UNITED STATES PATENT AND TRADEMARK OFFICE

Office Action Summary

10/648,164

DETAILED ACTION

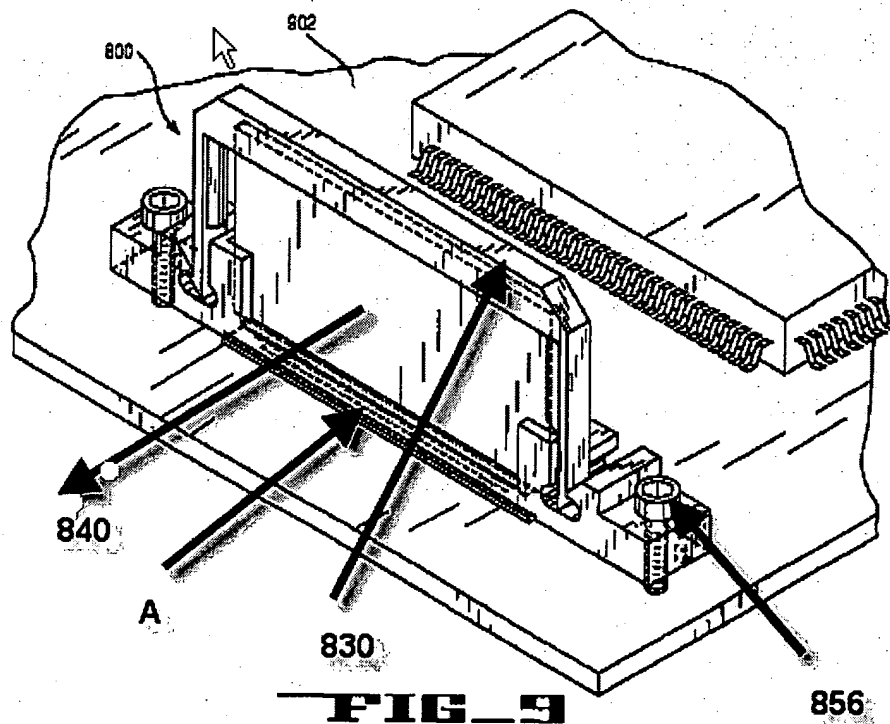
With regard to claim 14,21, Perino et al. discloses device comprising: at least one semiconductor device 840 including a plurality of contacts 842 located proximate a single edge of thereof; a retainer 830 including at least one receptacle configured to receive another edge of the at least one semiconductor device 840; and at least one mounting element 856 associated with the retainer 830 and configured to secure the at least one semiconductor 840 to a carrier 902. (Note see fig on page 6 of this office action, and figs. 8,9 of Perino et al.).

With regard to claims 15,19, Perino et al. discloses an alignment device A configured to be mounted to the carrier 902 wherein the alignment device A includes at least one receptacle configured to receive at least the single edge of the at least one semiconductor device 840. (Note see fig on page 6 of this office action, and figs. 8,9 of Perino et al.).

With regard to claim 16, Perino et al. discloses the alignment device A is configured to engage by the at least one mounting element 856. (Note see fig below, and figs. 8,9 of Perino et al.).

With regard to claim 16, Perino et al. discloses the alignment device A is configured to engage by the at least one mounting element 856. (Note see fig below, and figs. 8,9 of Perino et al.).
